The Network Rail (Leeds to Micklefield Enhancements) Order
CD 8.02 – Rebuttal Proof of Evidence of Michael Westwood

**REBUTTAL PROOF OF EVIDENCE
OF
MICHAEL WESTWOOD**

Document Reference	CD 8.02
Author	Michael Westwood
Date	20 February 2024

Figure 1: Depiction of possible additional land required to provide a ramped bridleway bridge at Peckfield Level Crossing

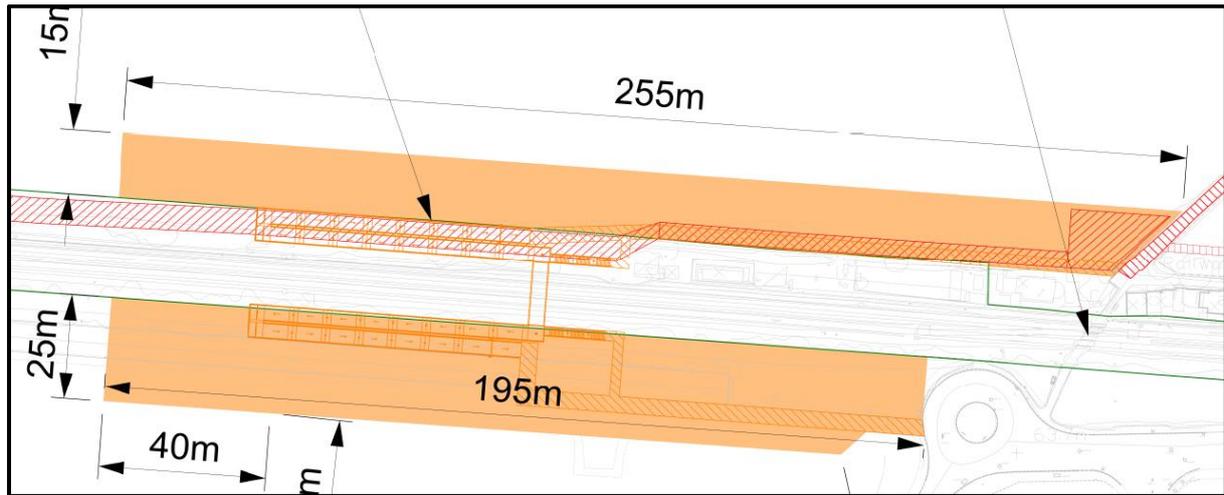
It is consequently contended that the construction of a bridleway bridge could be considered further if the Secretary of State decides that the proposed alternative right of way is not suitable and convenient.

2.6.5 In addition, a bridleway bridge cannot be delivered wholly within Network Rail land nor within the land requested within the Order. Increased areas of permanent land acquisition would be required to the north and south of the railway to construct the bridge and for routing the associated access paths (refer to Figure 1 below).
